UNITED STATES PATENT AND TRADEMARK OFFICE

Office Action Summary	Application No. 10/671,842	Applicant(s) BROOKSHIRE, MICHAEL D.	
	Examiner David C. Reese	Art Unit 3677

DETAILED ACTION

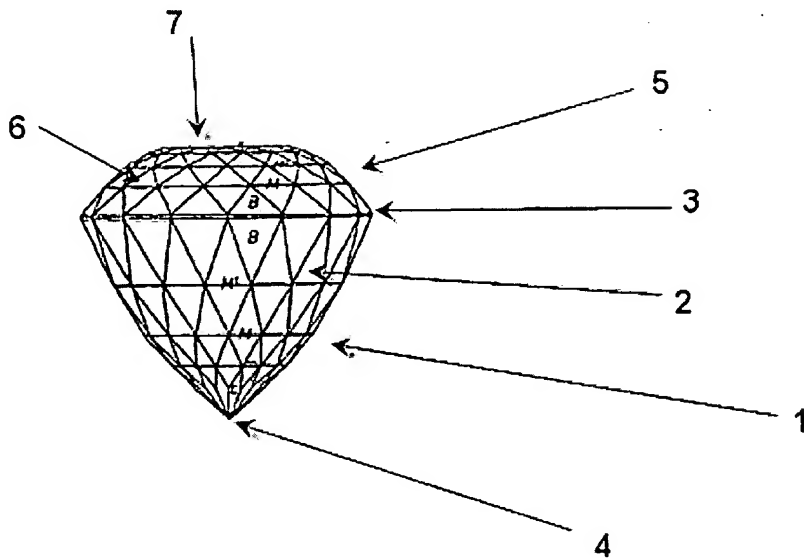
As for Claim 40, Diagrams for Faceting reference discloses of a cut gemstone (see figure 9), comprising:

a pavilion (1) having a plurality of facets (2) disposed from a girdle (3) to a culet (4); and
a dome-shaped crown (5) disposed above the girdle (3), wherein the girdle (3) extends no further than a widest circumference (bottom of 5) of the dome-shaped crown (5) and the pavilion (1) extends no further than a widest circumference of the girdle (3), the dome-shaped crown (5) formed from a plurality of sets of facets (6) cut with monotonically decreasing angles to form a curved contour in accordance with a dome shape from the girdle (3) to an apex (7) of the dome-shaped crown (5), each facet (6) within the sets of facets (6) being polygonal in shape with opposing corners of the polygon nested between adjacent facets (6).

Re: Claim 44, wherein the dome-shaped crown (5) is formed from at least five sets of facets (6) (see also figure ID on page 9 of "Diagrams") with monotonically decreasing angles to form the curved contour in accordance with the dome shape (5).

As for Claim 47, Diagrams for Faceting reference discloses of a cut gemstone (see figure below), comprising:

a pavilion (1) having a plurality of facets (2) disposed from a girdle (3) to a culet (4); and
a dome-shaped crown (5) disposed above the girdle (3), wherein the girdle (3) extends no further than a widest circumference (bottom of 5) of the dome-shaped crown (5) and the pavilion (1) extends no further than a widest circumference of the girdle (3), the dome-shaped crown (5) formed from a plurality of sets of facets (6) cut with monotonically decreasing angles to form a curved contour in accordance with a dome shape from the girdle (3) to an apex (7) of the dome-shaped crown (5).

Re: Claim 48, wherein each facet (6) within the sets of facets (6) is polygonal in shape with opposing corners of the polygon nested between adjacent facets (6).

Re: Claim 54, wherein the dome-shaped crown (5) is formed from at least five sets of facets (6) (see also figure ID on page 9 of "Diagrams") with monotonically decreasing angles to form the curved contour in accordance with the dome shape (5).

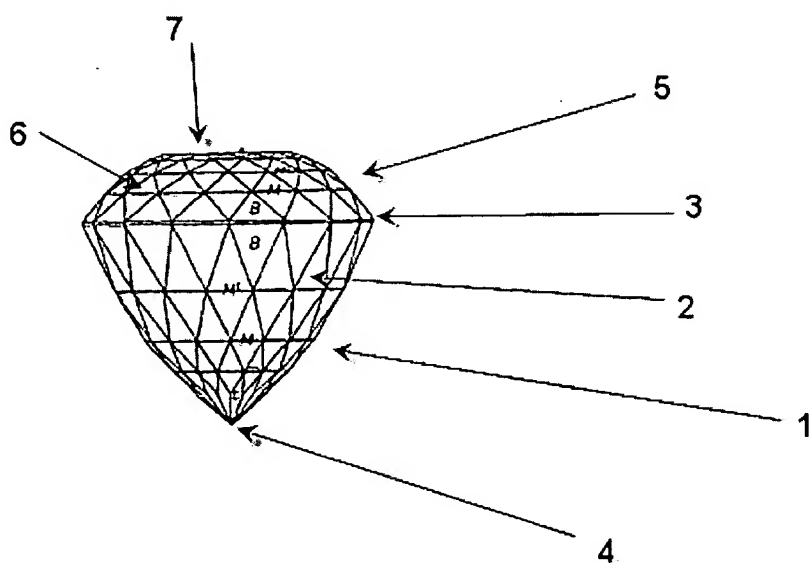
As for Claim 1, Diagrams for Faceting reference teaches of a diamond (see figure below), comprising:

a pavilion (1) having a plurality of facets (6) disposed from a girdle (3) to a culet (4), each of the plurality of facets (6) having a continuous flat surface extending from the girdle (3) to the culet (4), wherein an edge of a first adjoining facet contacts an edge of a second adjoining facet along a common radial boundary; and

a dome-shaped crown (5) disposed above the girdle (3), wherein the girdle (3) extends no further than a widest circumference (bottom of 5) of the dome-shaped crown (5) and the pavilion (1) extends no further than a widest circumference of the girdle (3), the dome-shaped crown (5)

formed from at least five sets of facets (6) with monotonically decreasing angles to form a curved contour in accordance with a dome shape from the girdle (3) to an apex (7) of the dome-shaped crown (5), each facet (6) within the sets of facets (6) nested between adjacent facets (6), each of the sets of facets (6) having monotonically decreasing surface area from the girdle (3) to the apex (7) of the dome-shaped crown (5).

The difference between the claim and "Diagrams" is that "Diagrams" does not expressly disclose that each facet (6) within the set of facets (6) being hexagonal in shape; and that the apex (7) of the dome-shaped crown (5) has less surface area than each facet (6) from the sets of facets (6). It would have been an obvious matter of design choice to modify "Diagrams" (the aspect of the shape of the facets within the sets of facets, and of the apex having less surface area than each facet within the sets of facets) since applicant has not disclosed that such a particular

As for Claim 13, "Diagrams" teaches of a diamond (see figure above), comprising:

a pavilion (1) extending from a girdle (3) to a culet (4), wherein the girdle (3) extends no further than a widest circumference of the crown (5) and the pavilion (1) extends no further than a widest circumference of the girdle (3); and

a crown (5) in the form of a symmetrical hemisphere formed from at least five sets of facets (6) between the girdle (3) and an apex (7) of the crown (5) having a first set of facets (6) disposed above the girdle (3) and a second set of facets (6) disposed between the first set (6) of facets and an apex (7) of the crown (5), wherein the first set of facets (6) is cut at a first angle with respect to a reference line which is tangential to the apex (7) of the crown (5) and the second set of facets (6) is cut at a second angle with respect to the reference line which is less than the first angle, each facet (6) within the first and second sets of facets (6) being hexagonal in shape with opposing corners of the hexagon nested between adjacent facets (in view of remarks above).

As for Claim 23, “Diagrams” teaches of a diamond (see figure above), comprising:
a pavilion (1) having a plurality of facets (2) disposed from a girdle (3) to a culet (4); and
a dome-shaped crown (5) disposed above the girdle (3), wherein the girdle (3) extends no further than a widest circumference of the dome-shaped crown (5) and the pavilion (1) extends no further than a widest circumference of the girdle (3), the dome-shaped crown (5) formed from

a at least five sets of facets (6) cut with monotonically decreasing angle to form a curved contour in accordance with a dome shape from the girdle (3) to an apex (7) of the dome-shaped crown (5), each facet (6) within the first and second sets of facets (6) being hexagonal in shape with opposing corners of the hexagon nested between adjacent facets (in view of remarks above).
